CCK-2607.0-1-24

Replace AHU 3 at Pav WH

ADDENDUM # 2

Project Name: UK Pav WH - AHU-3 Replacement 11289
Project Number: 25130.00
Document Set Name: Bid/Construction

SHEET #
M-104

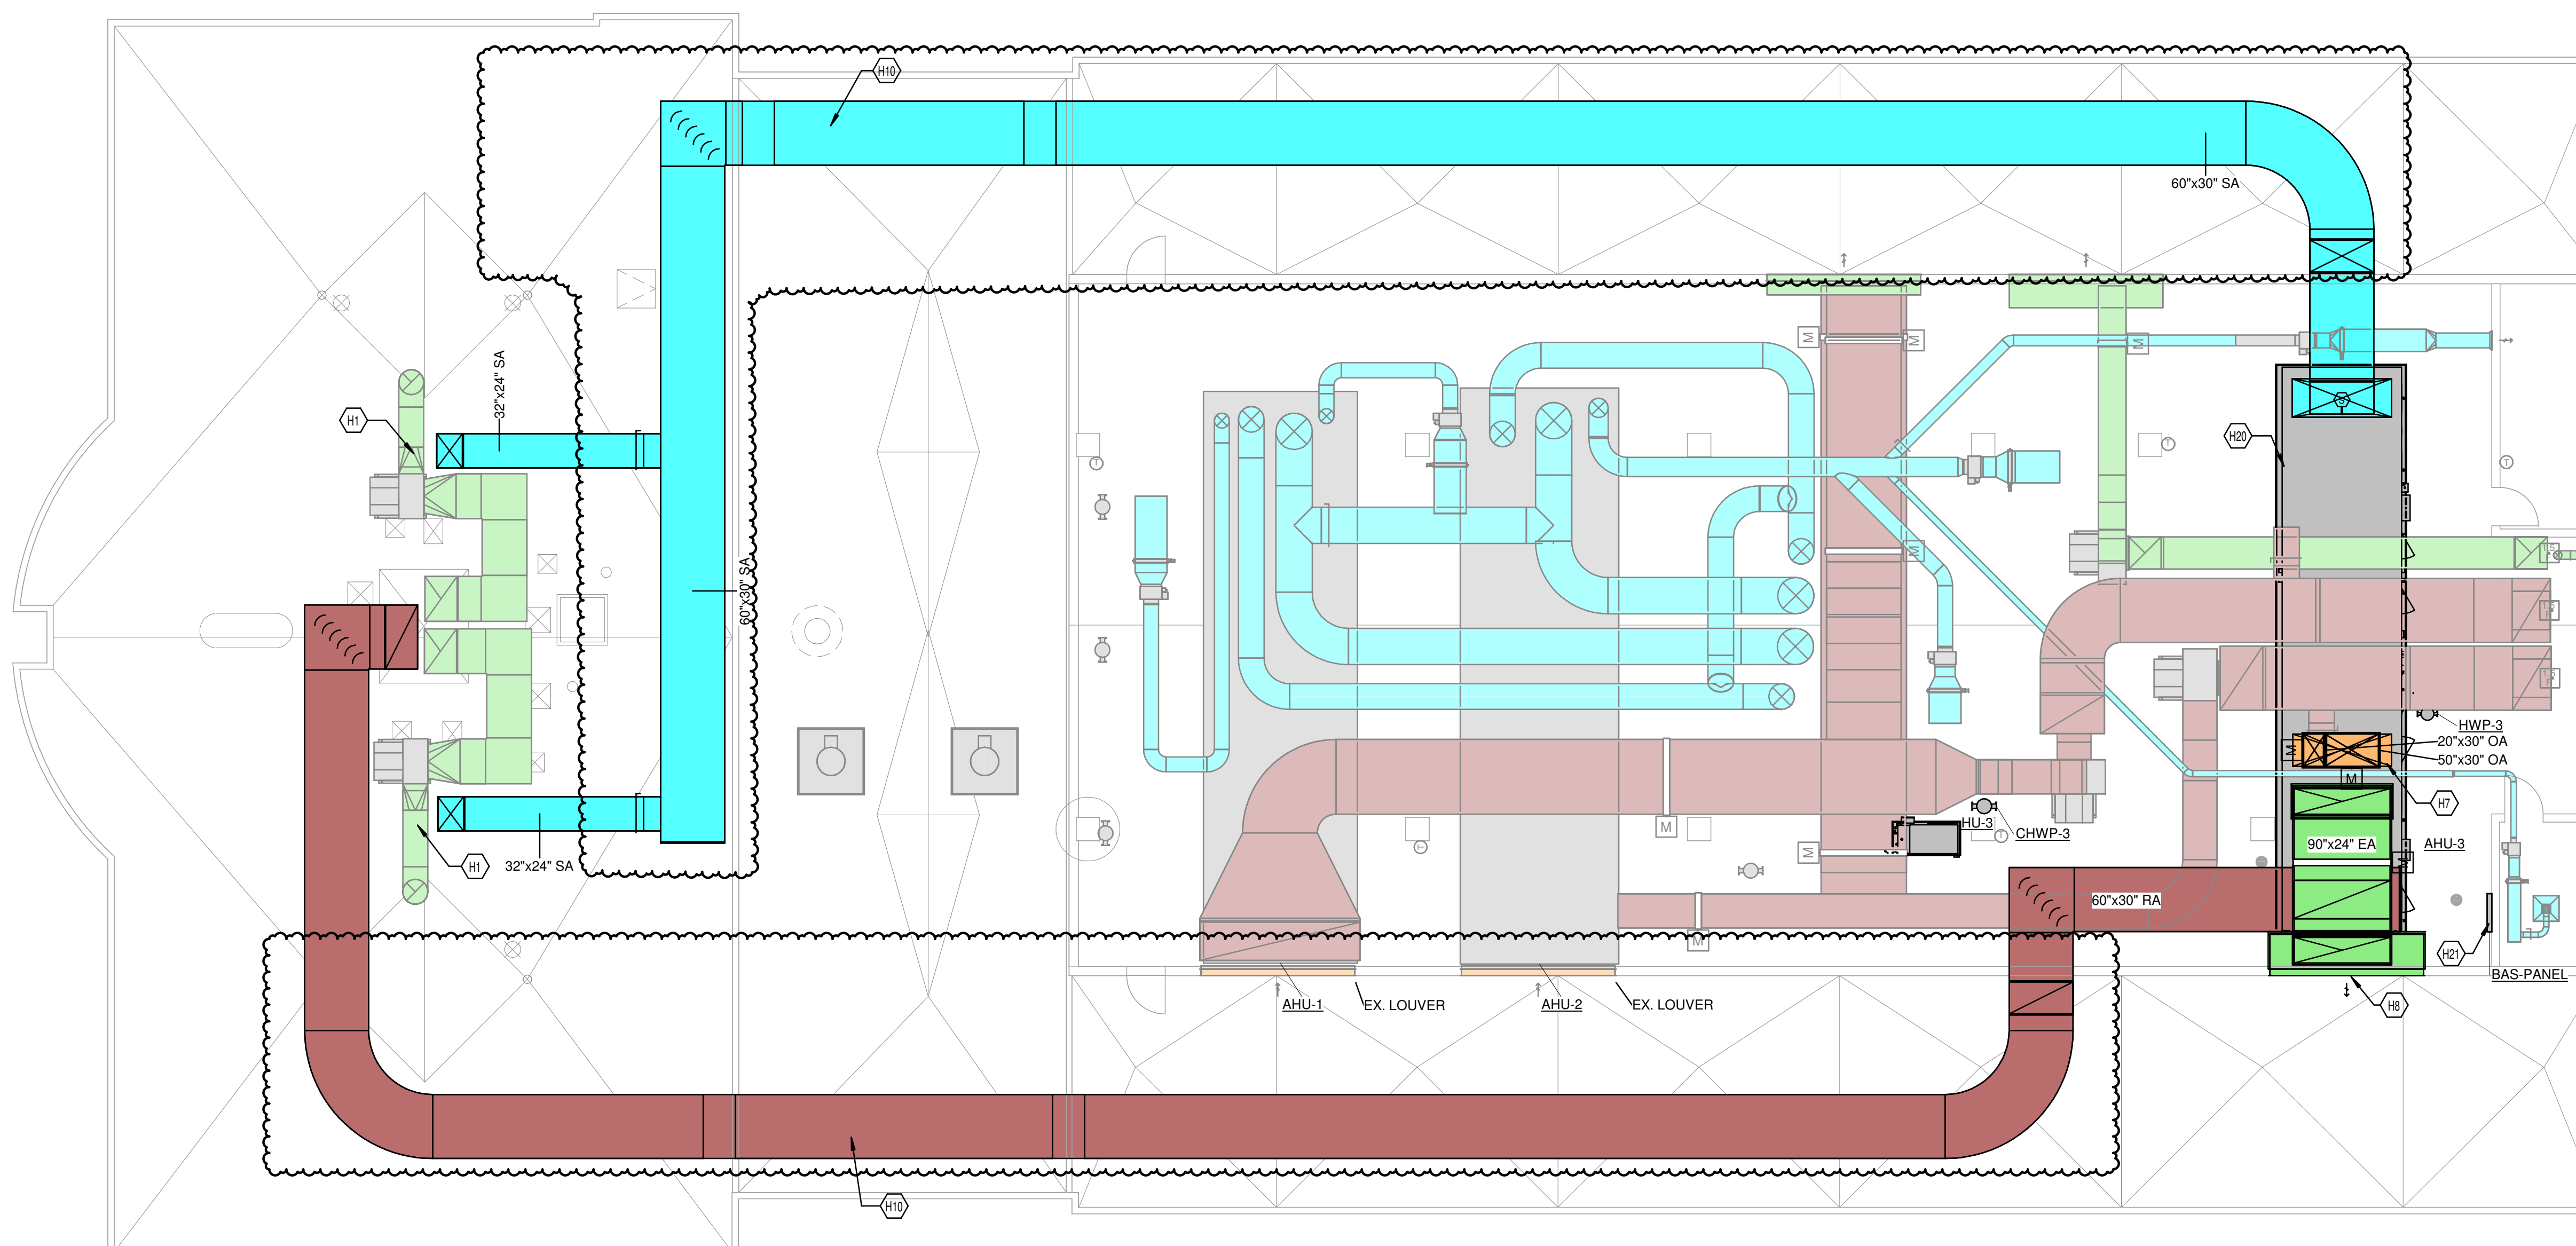
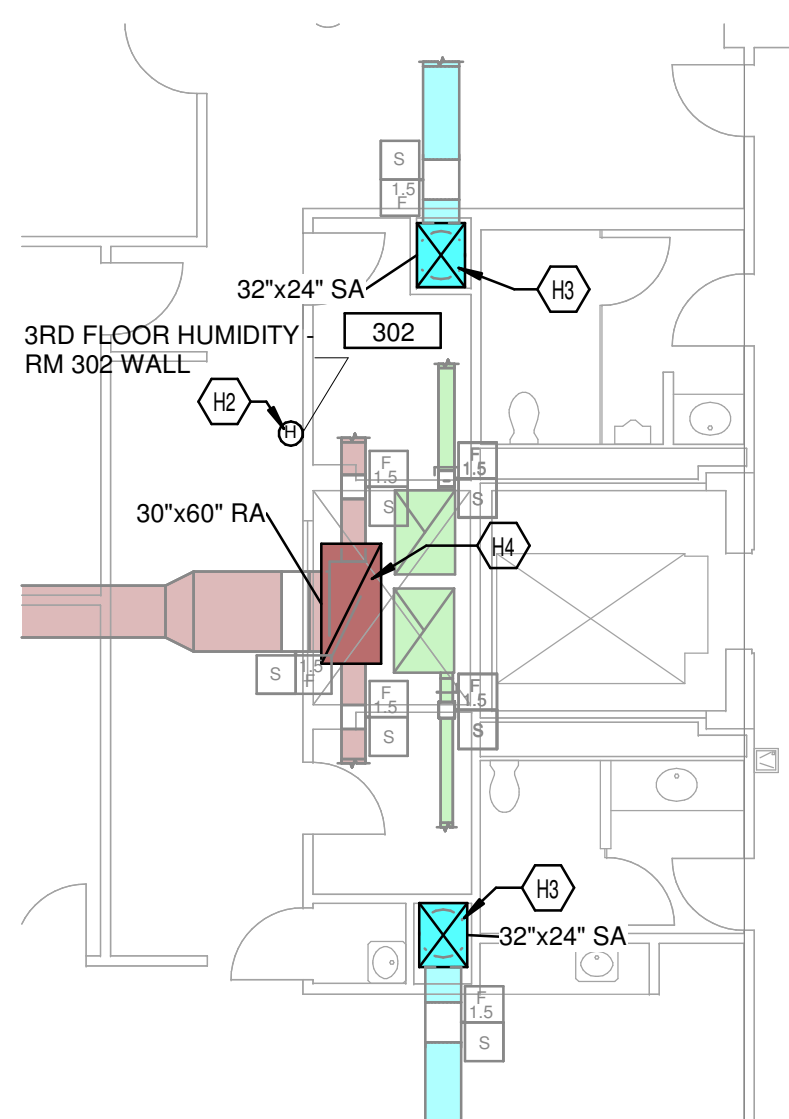
7	Clarify and provide details for Note H-20 on print M-104.	Maintenance requested an easier way to replace motors. AHU-3 basis of design unit includes a rail system. Bid alternate would entail providing a Unistrut trolley and attaching a chain fall.
8	Is there a temporary unit required, PROJECT DESCRIPTION: Replace AHU 3 in Pavilion WH. Furnish and install a temporary AHU for climate control during the replacement.	No temporary unit required.
9	Please provide wall details where new louver is to be cut in.	Please see attached architectural as built for reference. See A-8.2 detail 5 (LV1) and A-9.4 detail 5.
10	Please provide PAV WH roofing contractor	Insulated Roofing for the north tower roof and the new roof replacement (penthouse side) is by Isaac Roofing.
11	Please provide Roof curb, and roofing details, for level 3 roof	Please see detail 233113.00-07 on M-501.
12	Please provide layouts, details, fan size, location, & specifications, Alt #1- "Combine existing exhaust ductwork and replace existing exhaust fan. Refer to Keyed Note H1 on sheet M-104."	The design intent is to clean up the existing lab exhaust fan configuration. Alternate replacement fan shall be sized for 32,000 CFM at 5" ESP per original design conditions and shall be Greenheck model VEKTOR or equivalent.

Revision Narrative

- 1) Sheet M-104 - Mechanical Level 4 Plan Overall
 - a) Added more detail to bid alt.
 - b) Moved ductwork outside of penthouse. Extended prefabricated exterior ductwork system.
 - c) Removed note about roofing contractor.
- 2) Sheet M-502 - Mechanical - Details
 - a) Updated AHU BOD.
- 3) Sheet M-601 - Mechanical - Schedules
 - a) Updated humidifier steam value.
 - b) Added notes to AHU.
- 4) Sheet MD100 - Mechanical Demolition Ground Floor Plan Overall
 - a) Alternate demolition duct noted.
 - b) Added relocation of VFD.
- 5) Sheet MP-100 - Mechanical Piping Ground Floor Plan
 - a) Added note where existing tank is located.
 - b) Added note about piping material.
 - c) Added relocation of VFD.
- 6) Sheet MP-104 - Mechanical Piping Level 4 Plan
 - a) Added connect to existing symbols.

H20	BID ALTERNATE: PROVIDE NEW ACCESS HATCH AND NEW HOIST AND TROLLEY SYSTEM FOR MOTOR REPLACEMENT. SEAL EXISTING PENTHOUSE FLOOR.
H21	PROVIDE DRISTEEM VAPORLOGIC CONTROLLER TO INTEGRATE RO TREATMENT SYSTEM AND HUMIDIFIER.
H22	PROVIDE NEW DUCTWORK STATIC PRESSURE SENSOR.

SHEET #
MP-104

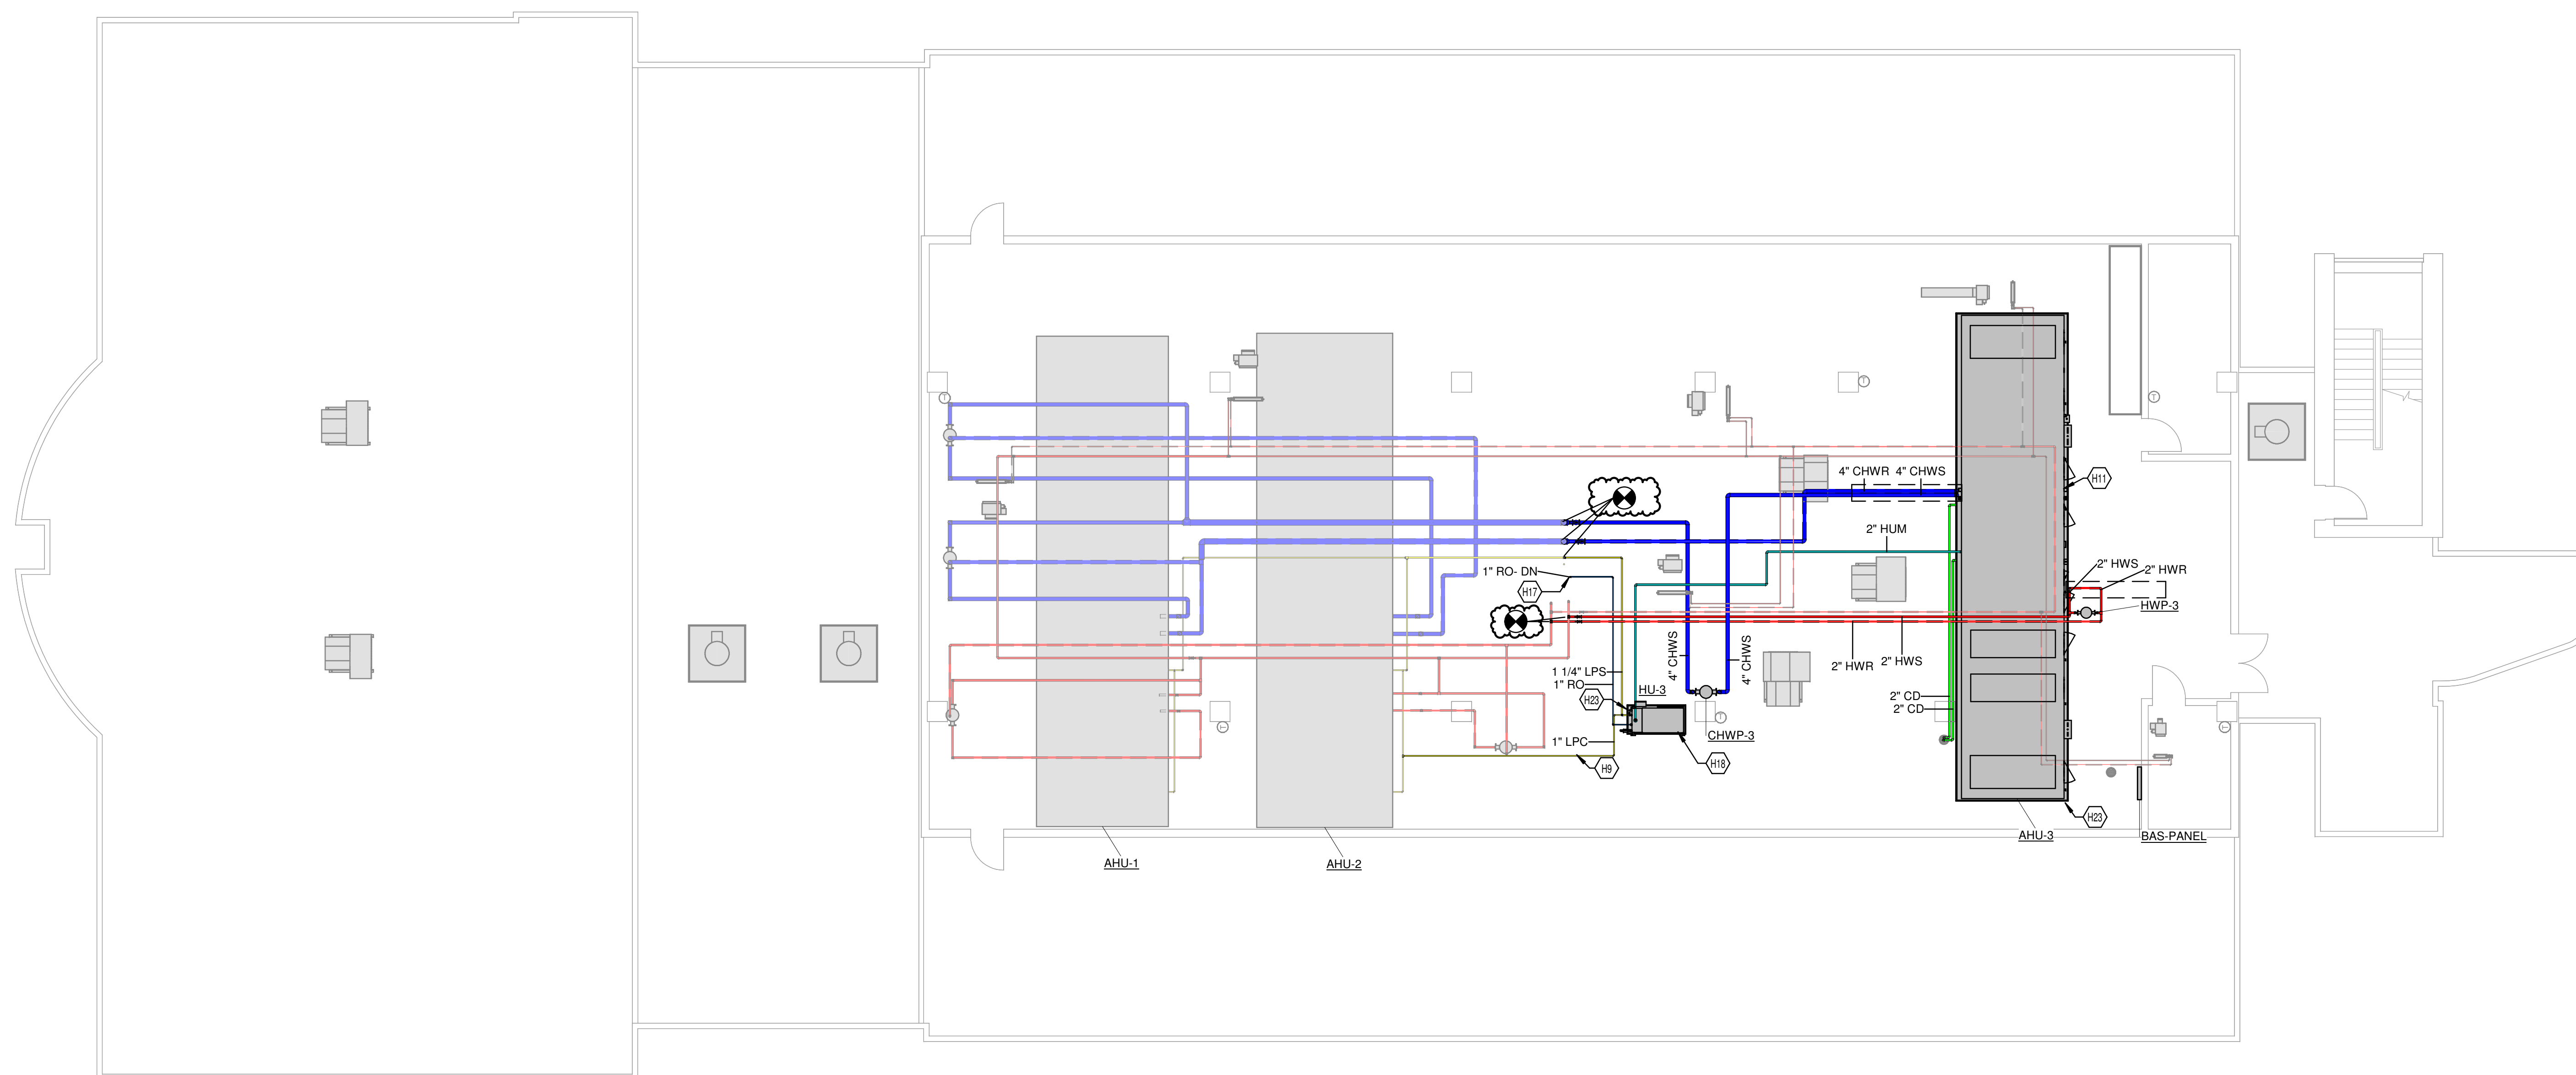
17	Drawing MP-104, note H18, indicates a bid alternate, Alternate not shown on bid form.	The alternate is listed on the bid form/form of proposal.
18	Drawing MP-104. note 23, please provide thickness of pad.	4".
19	Above ground Hydronic Piping, will Victaulic grooved piping be acceptable for CHWS/R piping 2 1/2" and up	Please bid without Victaulic and recommendation can be evaluated after project is awarded.
20	Please indicate tie-in points for CHWS/R, HWS/R, and LPC piping	Tie-in points indicated on MP-104. HW, CHW, LPS all enter penthouse between columns L.1 and N.1 (center chase). LPC to route low along duct and connect into LPC line serving AHU-2. Connect to existing tags will be added.
21	Looking at the drawing the units it will most likely need to be split for installation. Please confirm the max length of each split based on drawing MP-104.	15' max segments should be able to fit between opening and parapet.
